QUAD-CITIES
DPR-29

ATTACHMENT D
SIGNIFICANT HAZARDS CONSIDERATION

DRESDEN STATION UNITS 2 & 3
QUAD CITIES STATION UNITS 1 & 2
BACKFILL MODIFICATION

FIGURE 1

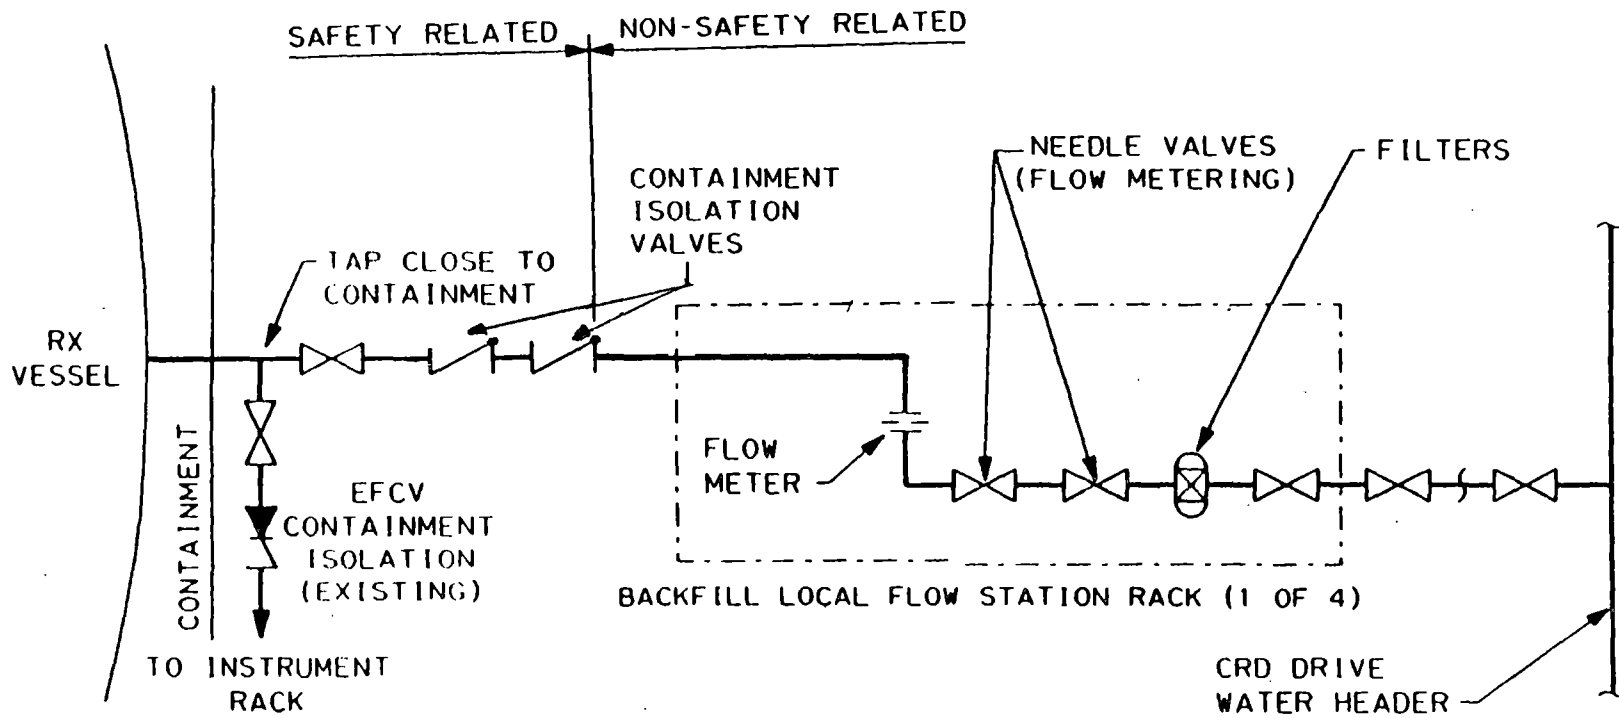
The proposed modifications (and proposed Technical Specification amendments) add reference leg backfill instrument lines and check valves to the reactor vessel level instrumentation. The proposed modifications will eliminate the phenomenon described in IEB 93-03 (dissolved gases in the RVLIS piping may produce uncertainties in the level instrumentation during RPV depressurization) by providing degassed Control Rod Drive (CRD) water to the RVLIS reference leg piping. The proposed design ensures that a continuous column of water, free of non-condensable gases is maintained in the RVLIS reference leg piping. As such, the proposed modifications do not affect any accident precursors or initiators. Therefore the proposed modifications for the reference leg backfill instrument lines do not increase the probability of any previously evaluated accidents for Dresden Station and Quad Cities Station.

The proposed modification connects the non-safety-related CRD system to each safety-related division of RPV instrumentation and Feedwater Level Control System. The backfill check valves will eliminate the potential for reference leg leakage if CRD piping integrity is lost. These check valves are classified as safety-related and will be maintained and controlled such that overall plant safety is maintained. The addition of the reference leg backfill check valves to the Technical Specifications does not create the possibility of a new or different kind of accident for Dresden Station or Quad Cities Station.

Primary containment integrity is not compromised by the addition of a pair of check valves that provide isolation for the reference leg backfill lines. These valves have been demonstrated to meet the intent of the criteria specified in General Design Criterion (GDC) 55. The maintenance and control applied toward all the reference leg backfill check valves ensures that overall plant safety is maintained. Therefore, the addition of the reference leg backfill valves to Technical Specification 3.7.D.1 and 3.7.D.2 does not reduce the margin of safety for Dresden Station or Quad Cities Station.
